**9-C-20-HZ**  
**APPLICATION FOR CERTIFICATE OF APPROPRIATENESS**

**1219 Luttrell St. 37917**  
**Fourth and Gill H-1**

# Staff Report - Certificate of Appropriateness Application

File Number: 9-C-20-HZ

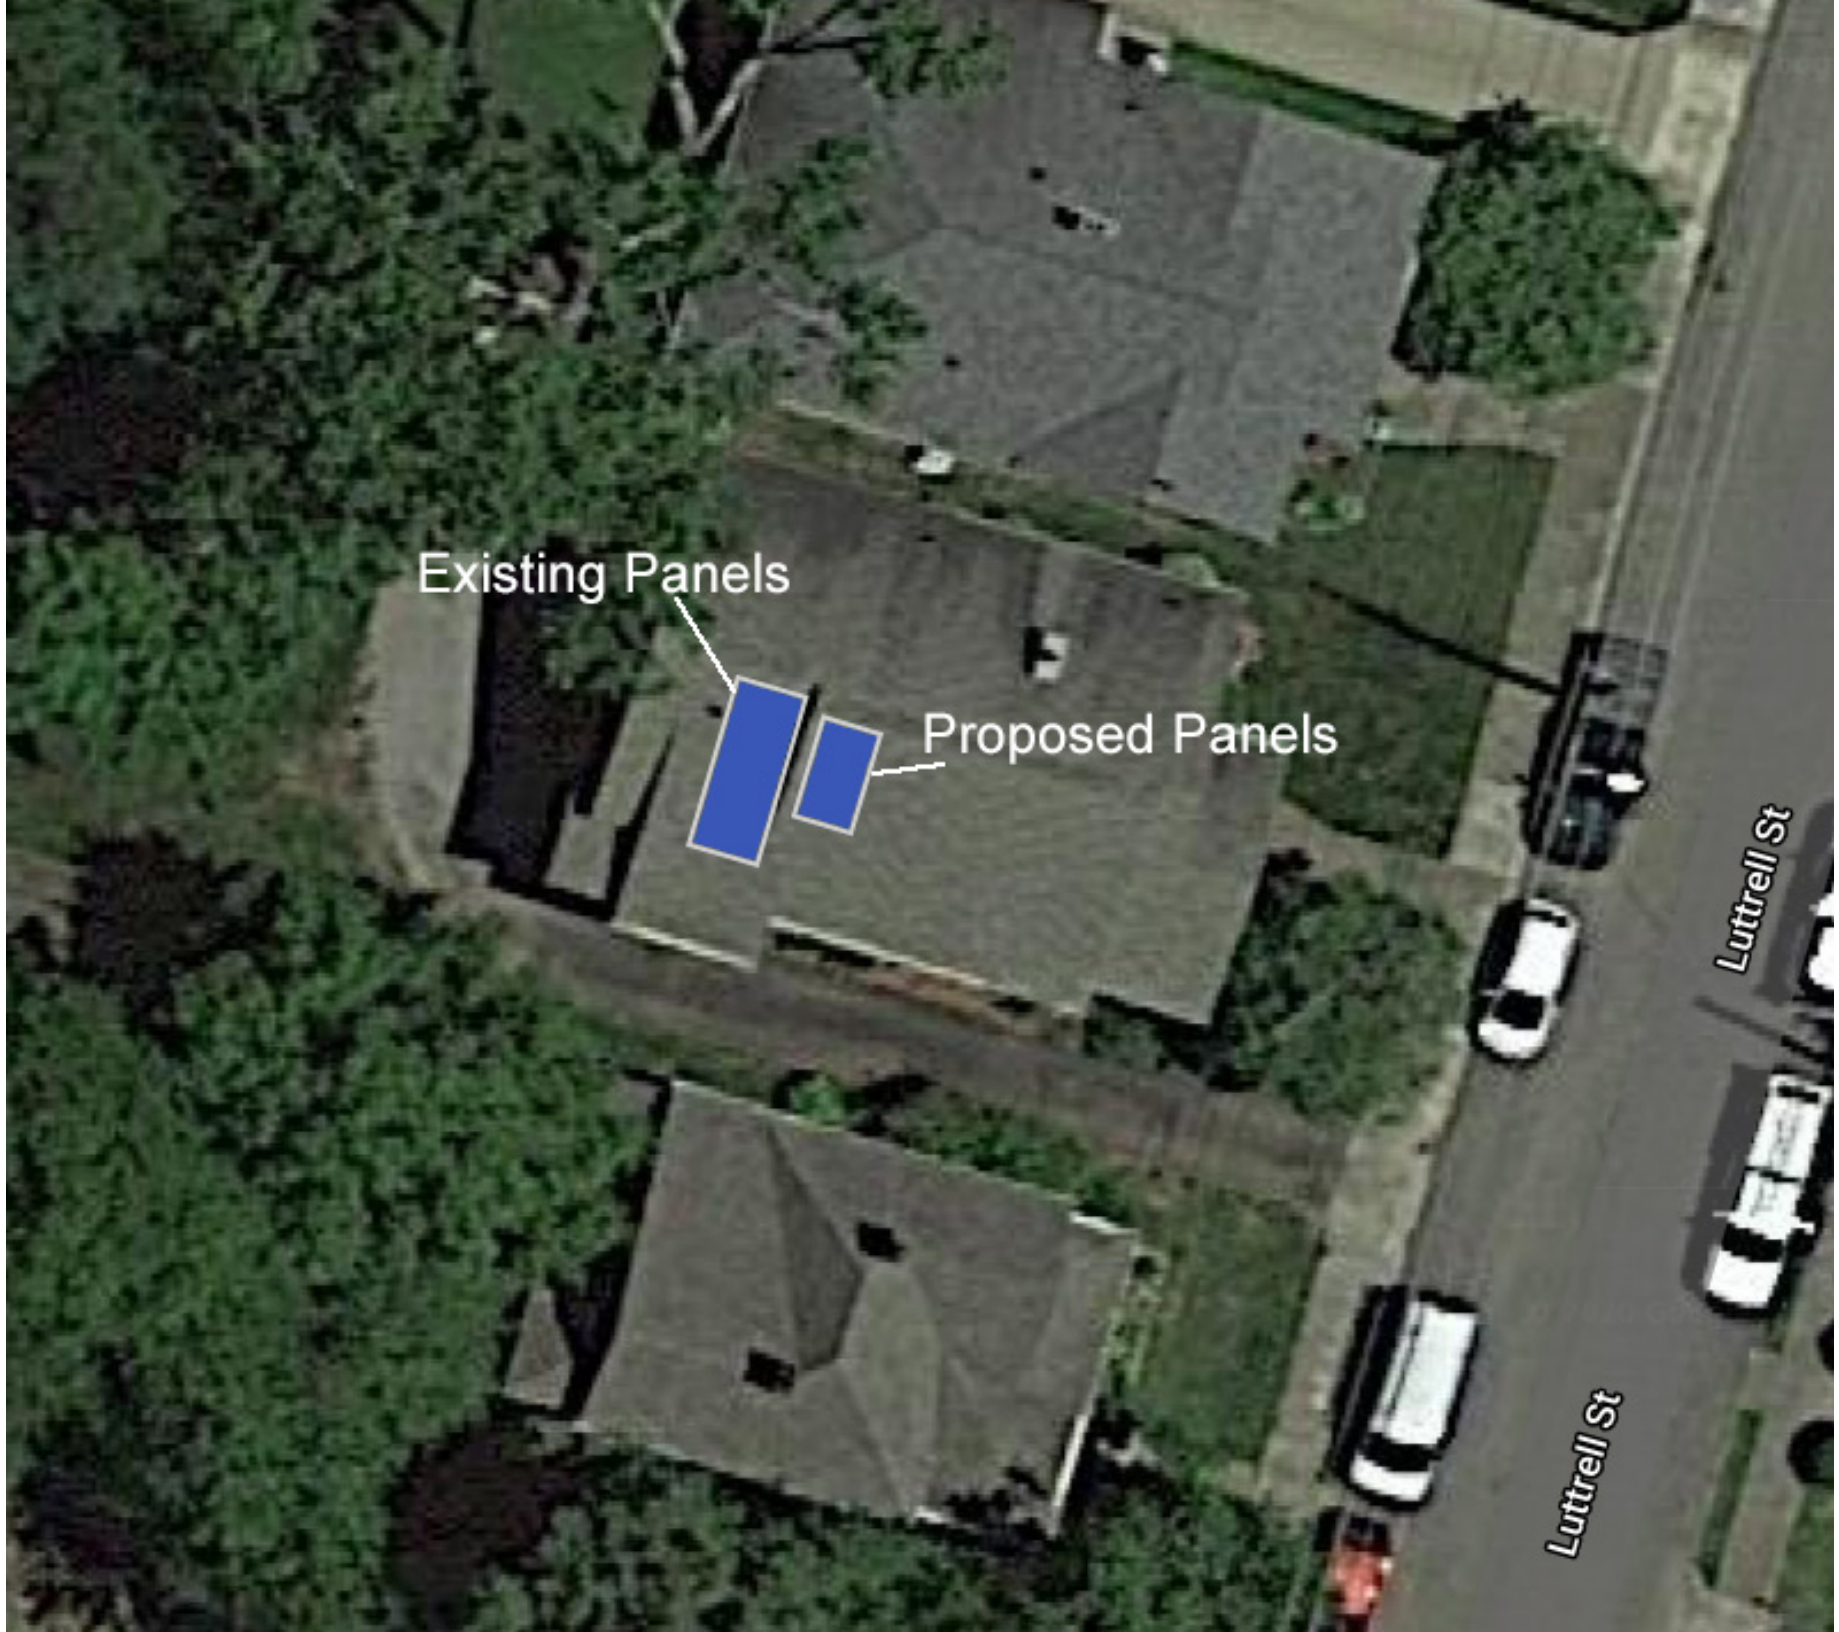
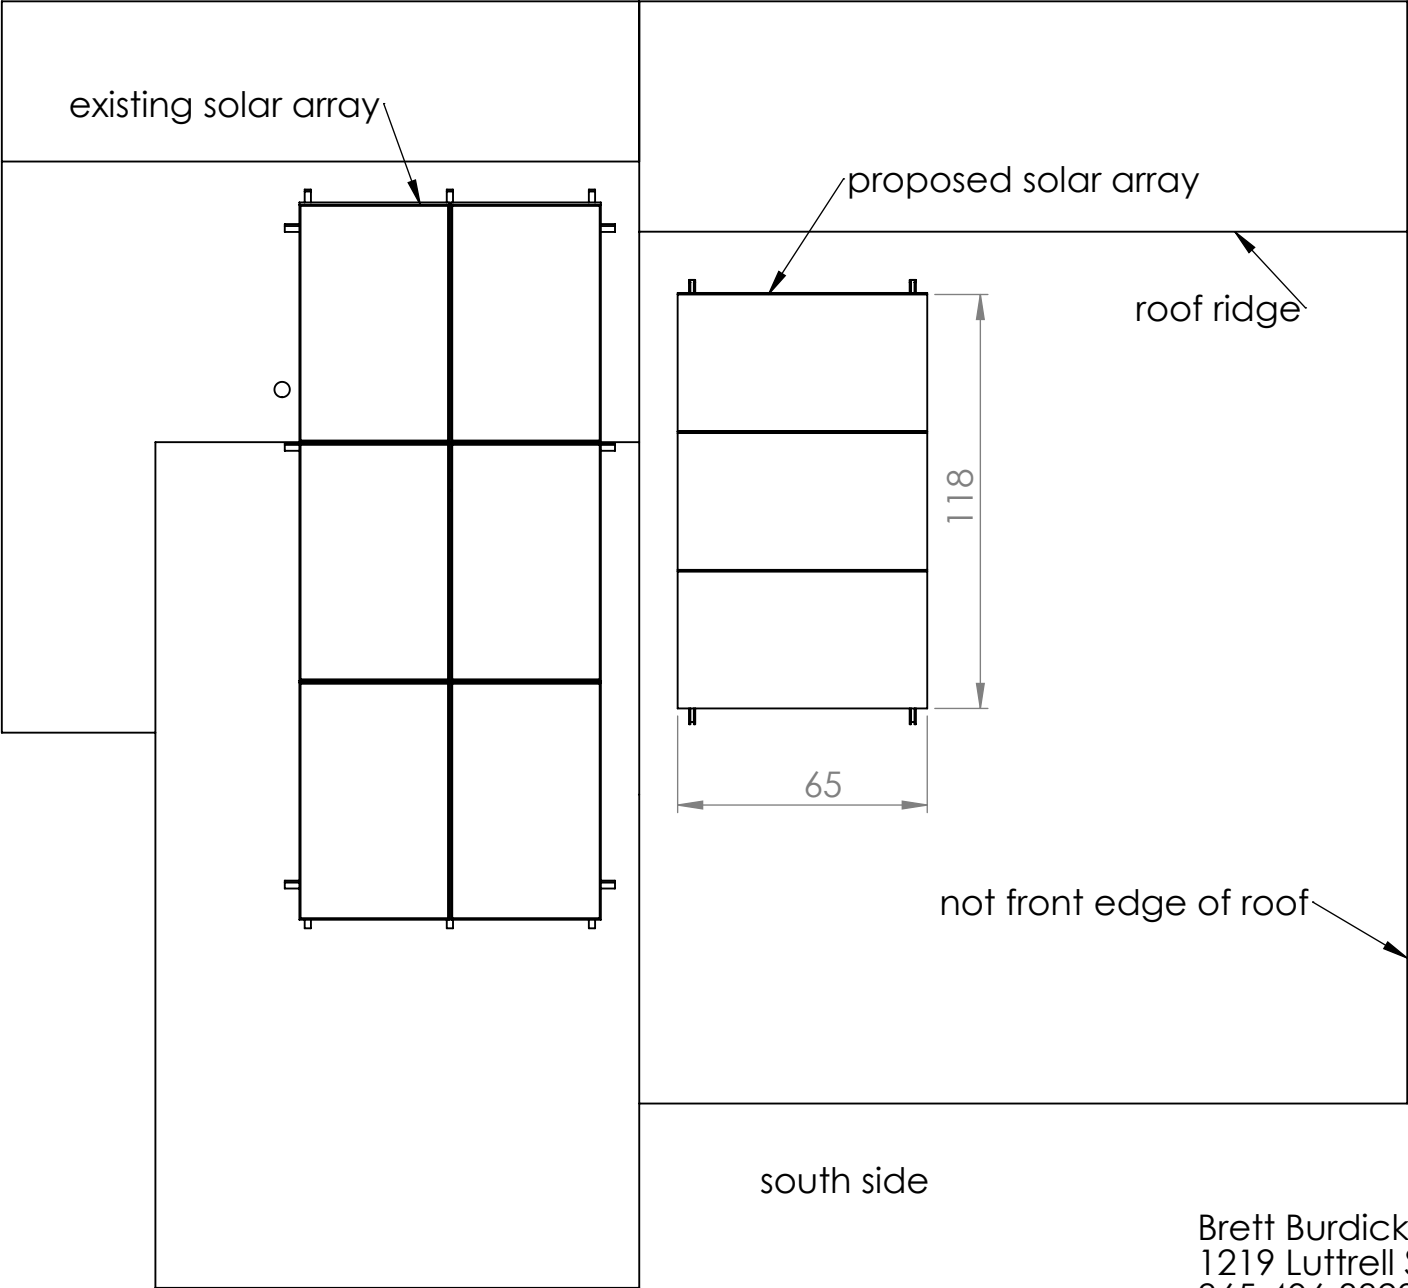
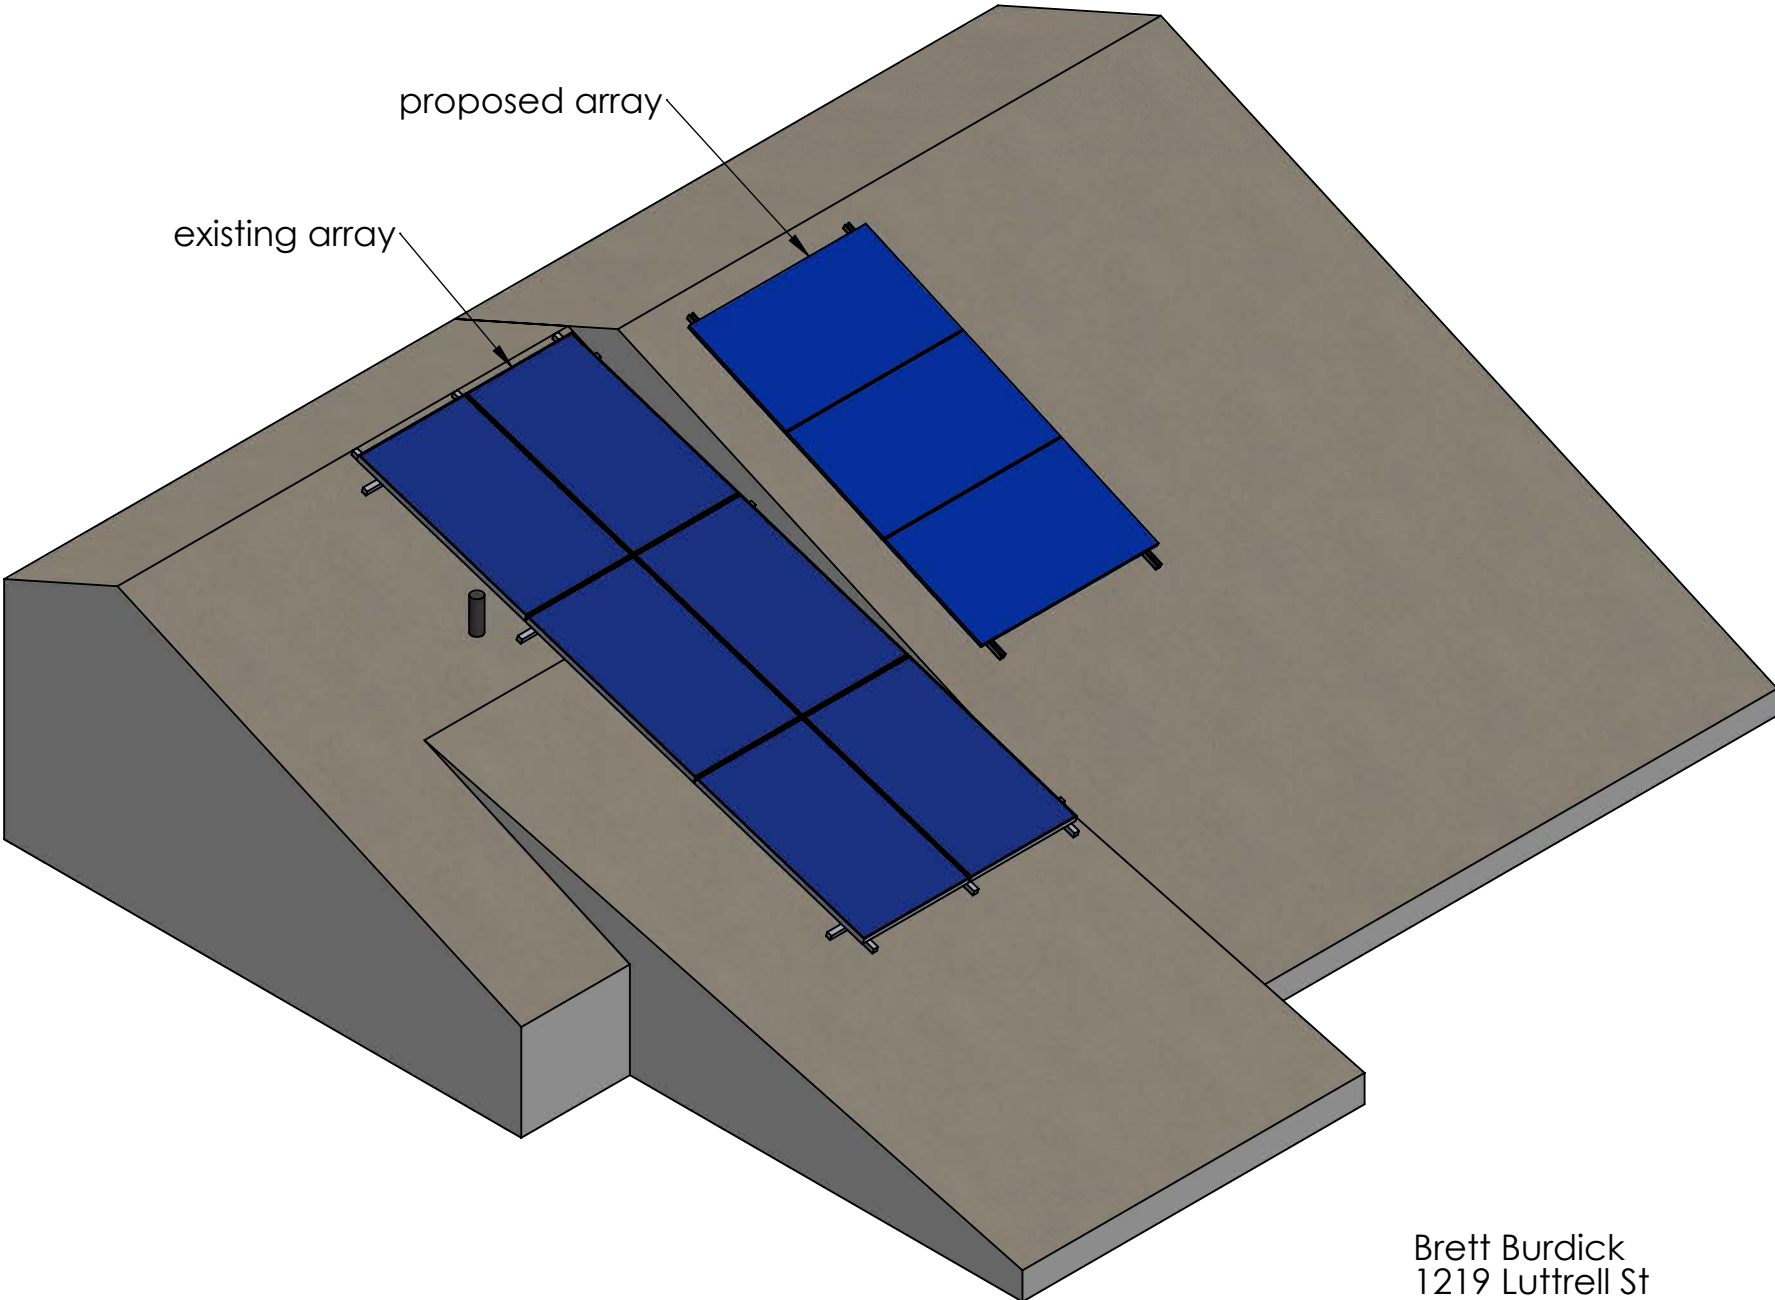
1. The house is a contributing structure to the Fourth and Gill National Register Historic District and local overlay.
2. The existing array of panels is located to the rear (west) of the house, and the second array is proposed to be placed adjacent to the existing panels on the right (east) side. The neighborhood-approved guidelines for solar panels encourage that panels should "not be visible from public streets, or, if visible, should be installed on an accessory building, a rear-facing elevation, or a side elevation that does not face onto the public street." Further recommendations on placement encourage new panels to "not be located forward of any point of a roof slope facing a public street or closer than 1/3 the depth of the main body of the roof, if there is no slope toward the street." While the proposed panels (and the existing array) are somewhat visible from the public right-of-way, their placement is appropriate under these guidelines.

3. The proposed array will be somewhat visible from Luttrell Street. The existing roof is grey asphalt shingles. The proposed panels are black and would benefit from an anti-reflective coating to reduce visibility.

4. The proposed panels are 2" thick and will be installed flush to the roof slope. The existing array extends across two roof slopes, so the array is not flush to the roof slope and the side of the panels are clearly visible from the public right-of-way. At the tallest point (between the two roof intersections), the solar equipment does not appear to exceed more than 6" above the roof surface, narrowly meeting the design guidelines. However, guidelines encourage that framing equipment "including brackets, edging around solar collectors, and other metal features should be treated, color clad, or covered to be made as unobtrusive as possible and to minimize contrast between the solar connectors and any roofing materials."

Staff recommends approval of the work as proposed, with the condition that the applicant explore further options to reduce visibility on the existing panel framework (treatments, color-cladding, or covering, etc) and the proposed panels (anti-reflective treatments, etc) with approval by staff.
